CITY OF SAINT PAUL
HERITAGE PRESERVATION COMMISSION STAFF REPORT

FILE NAME: 716 Wilson Avenue, Schornstein House
DATE OF APPLICATION: September 17, 2015
APPLICANT: Saint Paul Housing and Redevelopment Authority (HRA)
OWNER: HRA
DATE OF PUBLIC HEARING: October 22, 2015
HPC SITE/DISTRICT: Dayton's Bluff Heritage Preservation District
CATEGORY: Non-Contributing
CLASSIFICATION: Demolition Permit
STAFF INVESTIGATION AND REPORT: Christine Boulware
DATE: October 2, 2015

RE: 716 Wilson Avenue Request for Demolition

Project No.: 15535.00
Re: Structural Condition Review of the building at 716 Wilson Ave.

Picture 3 – Fire Damage, Northeast Elevation

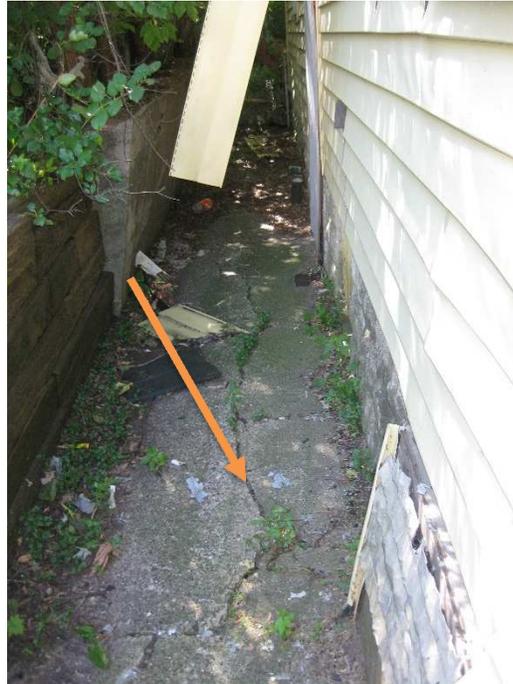
There is fire damage throughout the northeast end of the building, primarily the porch. Picture 1 and Picture 2 show the fire damage from within the home. The fire damage affected all of the beams that were visible in the front porch. It is also likely that the fire damaged more structural elements that were covered both in the porch and the main house. Fire damage can be seen on the finish throughout the building. Picture 3 shows the exterior elevation of the house at the north corner.
